# OVERLOOK at OXBOW

**To:** Cheryl Somerfeldt, Case Planner  
**From:** Jim Strozier, Consensus Planning, Inc.   
**Date:** February 6, 2019  
**Re:** Overlook at Oxbow: Project # 2018-00140

APPLICANT RESPONSE TO UPDATED COMMENTS 2/6/2019

**Re:** Project #: 2018-001402, SI-2018-00171 – Site Plan EPC

## CONCEPTUAL GRADING AND DRAINAGE PLAN

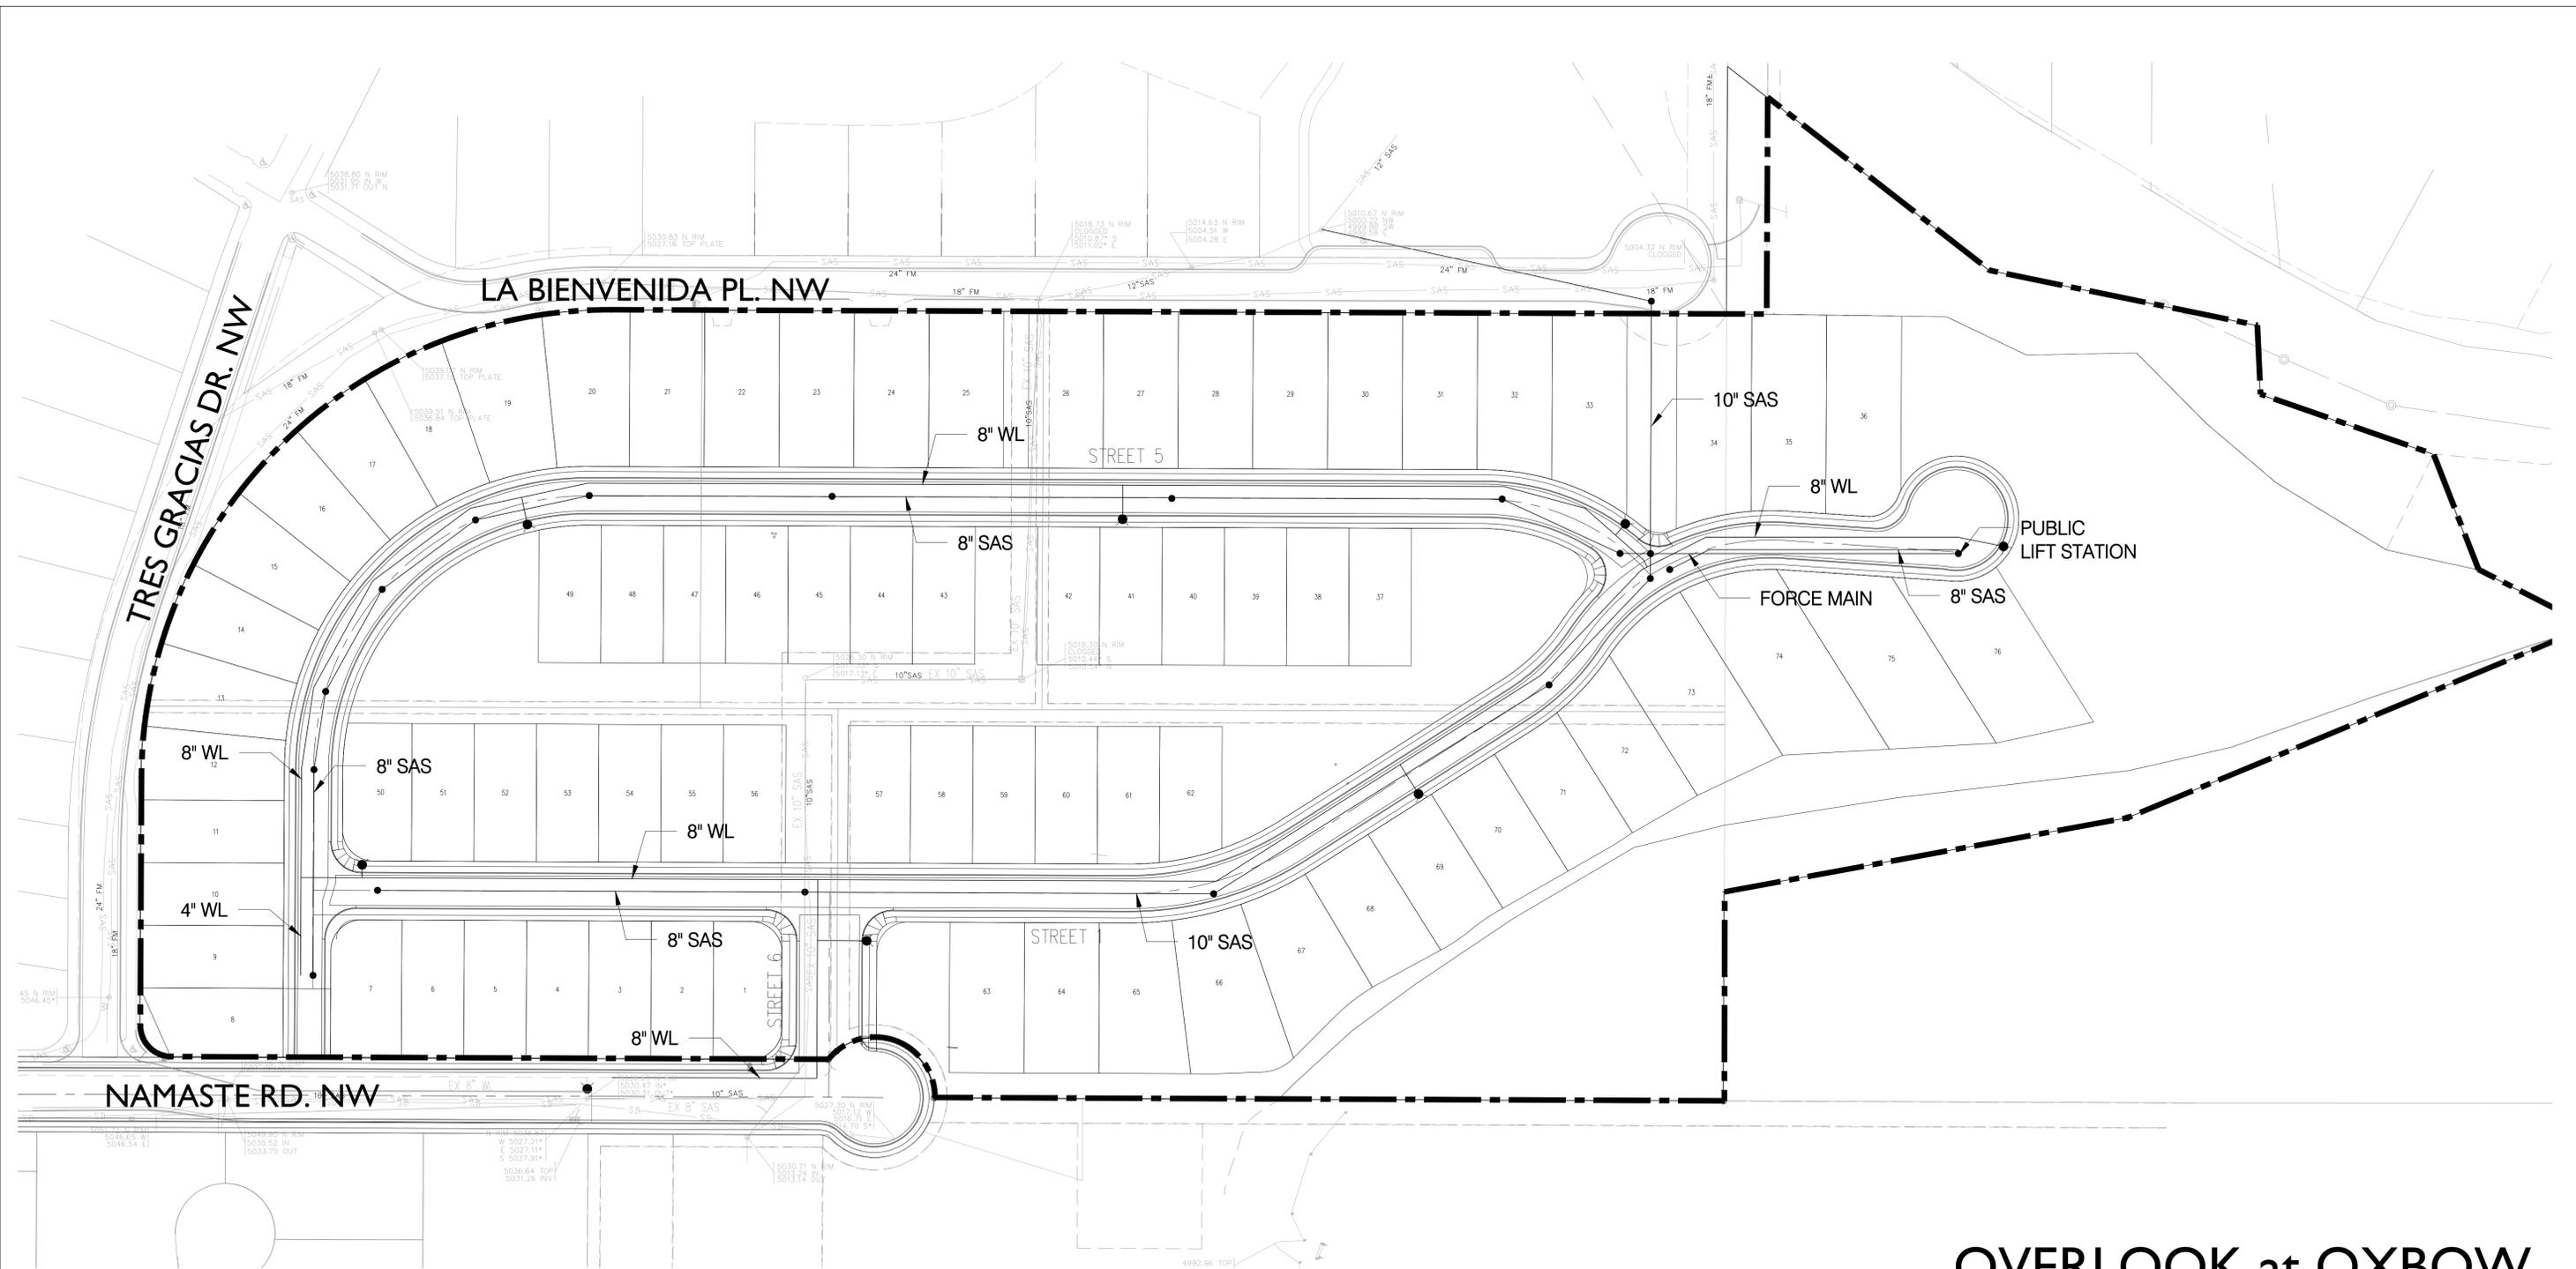
- 3) LOMR will be required to remove the floodplain from the lots that have the floodplain.  
*Agreed, Grading and Drainage Note #1 on the Conceptual Grading and Drainage Plan (Sheet 3) states: "A LOMR will be required to remove the flood plain from lots 34, 35, and 36.*

- 4) AMAFCA approval will be required for connection to their Channel and grading adjacent to their right of way.

- 5) USACE approval will be required for any fill proposed in Waters of the US.  
*Agreed, Grading and Drainage Note #3 states: "No fill is proposed or permitted in any designated Waters of the US".*

- 8) A prudent setback from the Rio Grande is recommended because the slope on City Open Space is not stable and subject to lateral migration of the river. The City has no plans to stabilize the slope and does not want to be burdened with the cost of such improvements. Bank Protection may be constructed to prevent lateral migration of the river, and erosion of the slope.  
*Agreed, Grading and Drainage Note #4 states: The existing pipe and wire mesh fence is*

- LOMR will be required to remove the floodplain from the lots that have the floodplain. *Grading and Drainage Plan, Sheet 3 Note 1.*
- AMAFCA approval will be required for connection to their Channel and grading adjacent to their right of way. *Grading and Drainage Plan, Sheet 3, Note 2.*

- USACE approval will be required for any fill proposed in Waters of the US. *Grading and Drainage Plan, Sheet 3, Note 3 – the project is not proposing any fill for areas considered Waters of the US.*

*considered to the prudent setback from the existing slope.” This is also represented on the Landscape Plan (Sheet 2) delineates the Sensitive Land Protection Area and states: No construction or disturbance to the extent possible. Disturbed areas shall be revegetated consistent with the existing conditions.”*

*As a separate component of this concern, which relates to the need to ensure that any bank stabilization that may be necessary in the future can be completed on the subject property and may not impact the adjacent MPOS, Grading and Drainage Note #5 states: “Bank stabilization may be constructed to prevent lateral migration of the river and erosion of the slope, if needed.” The Grading and Drainage Plan is also designed to alleviate the current condition in which the stormwater drainage for the developed portion of the property since it is directed to the AMAFCA Water Quality Facility in the northeast portion of the property, significantly reducing the amount of stormwater flowing to the east.*
